ADDENDUM NO. 1

RE: City of Ashdown, Arkansas
Smith Circle Drainage

ADDENDUM DATE: October 10, 2023

Job No.: AD-02-21
Scale: 1"=50'
Date: NOV 2022
Sheet 8A OF 8

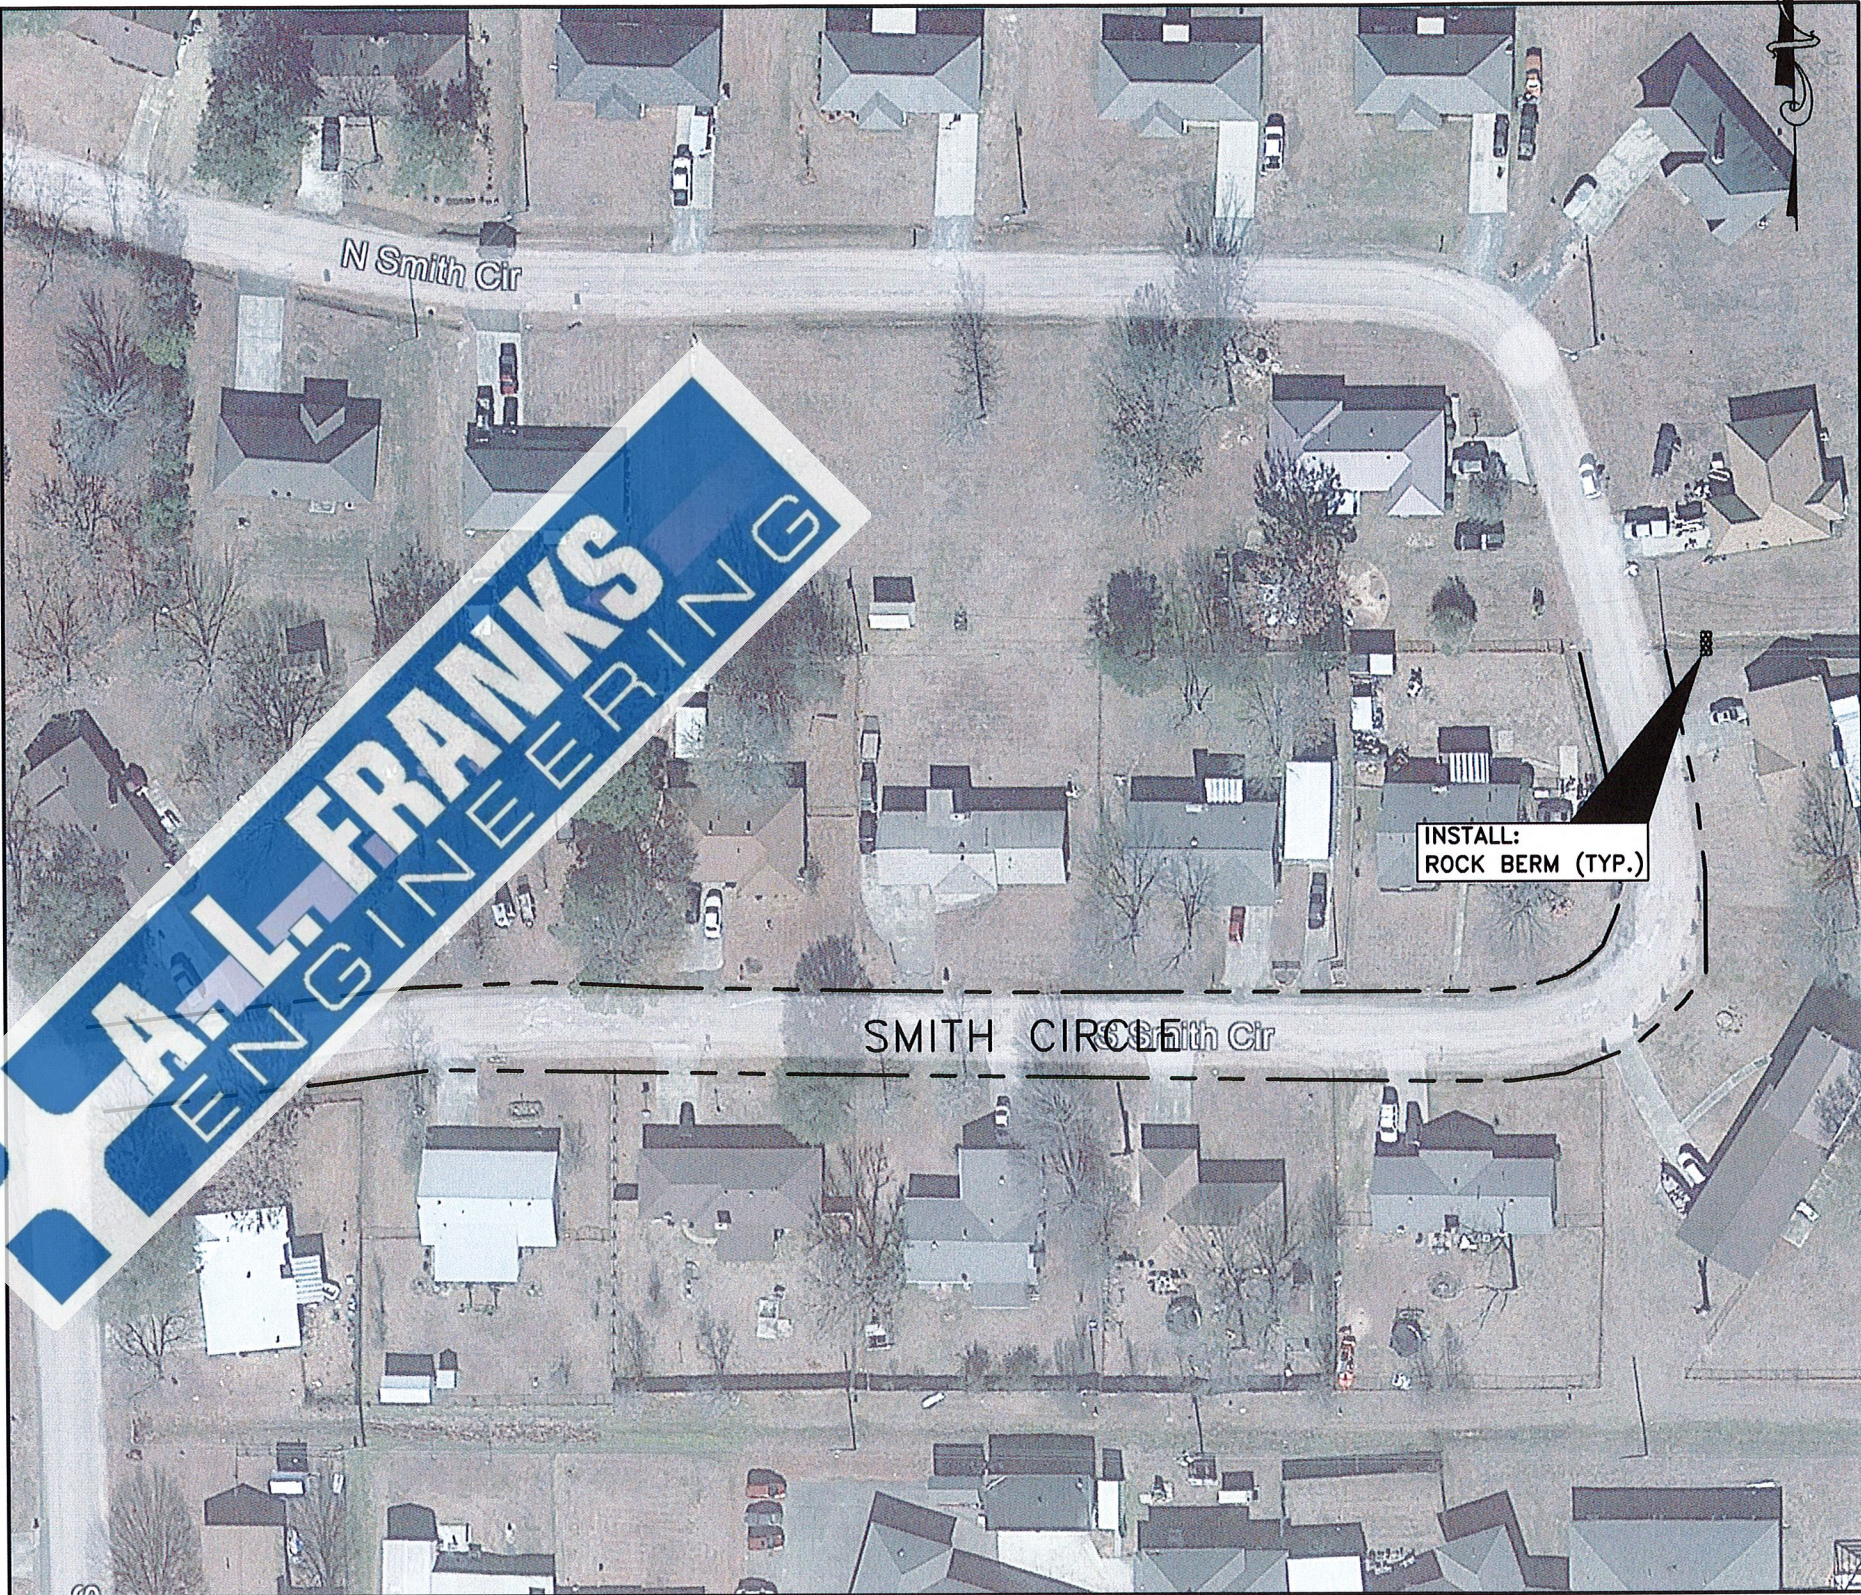
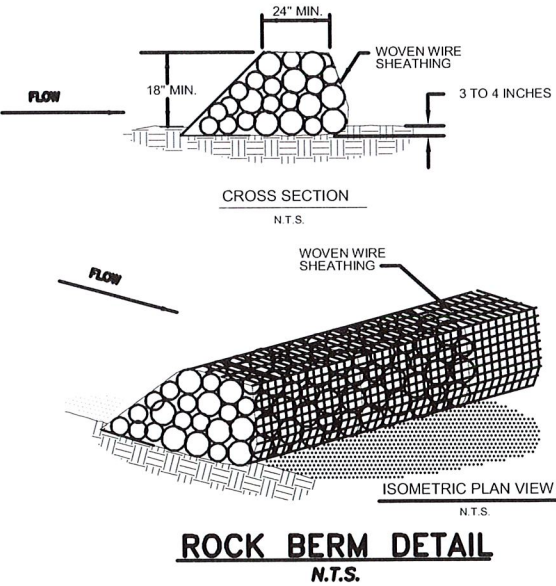
1. **Bid Proposal Clarification: Bid Proposal A & B: Bid Item #7**
Water Meter shall be re-set to match grade.
2. **Bid Proposal Clarification: Bid Proposal A & B: Bid Item #8**
Remove and Replace Brick Columns at Residence is for all five (5) columns and one (1) brick mailbox for a total of 6 Columns at this Residence.
3. **Bid Proposal:** Remove and Replace with Attached Bid Proposal.
4. **Plans:** Add Plan Sheet 8A (Attached).
